Product Change Notification					KEA and KEA-Print power entry module		
owner	creation date	release date	released by	change order no	rev	page	D10-032-663
sariogar	11.12.2018	25.03.2019	blumhe	2016811	A	1 of 4

KEA and KEA-Print power entry module

KEA screw-on mounting unwired

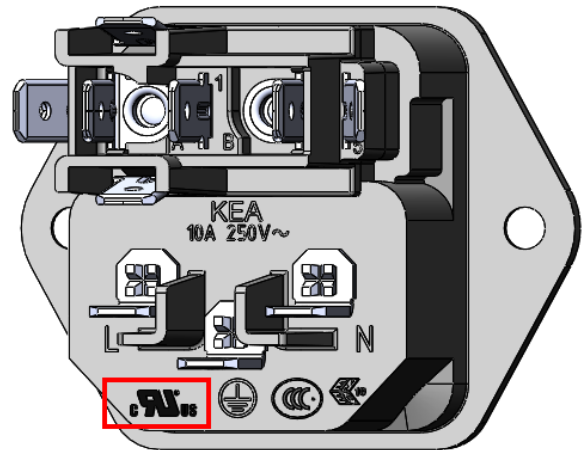
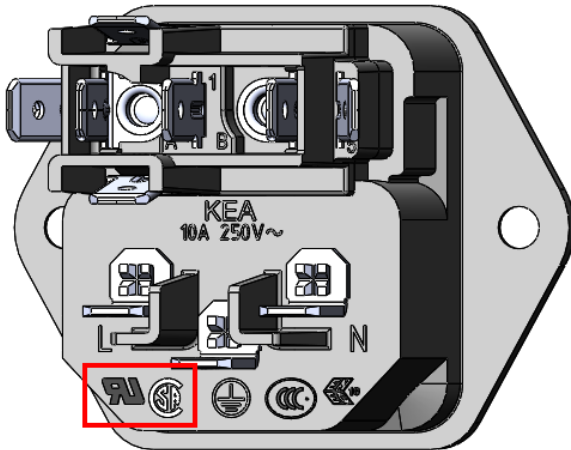
- Change of markings
- Modified packaging label

Standards update according to the new UL/CSA 60320-1.
When KEA-Print versions approval marks are covered by the ground terminal, the markers are shifted.
